TOPOGRAPHIC TITLE SHEET

Locality Outer Coast between Header Creek and Tiana Beach

REVIEW OF PHOTO TOPOGRAPHIC SURVEY NO.

REPORT ON REVIEW OF SHEET

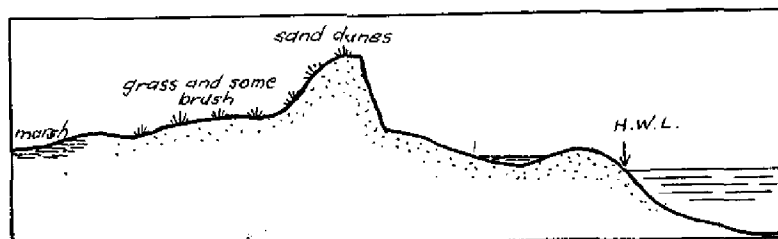
* The H.W. line as shown on this sheet is considered correct as of the date of the photographs. The low ridge of island at H.W. line as shown in the sketch on page 1 may have washed out prior to the date of the planotable survey several months after the photographs were taken. It seems probable from the discussion

that the ridge is
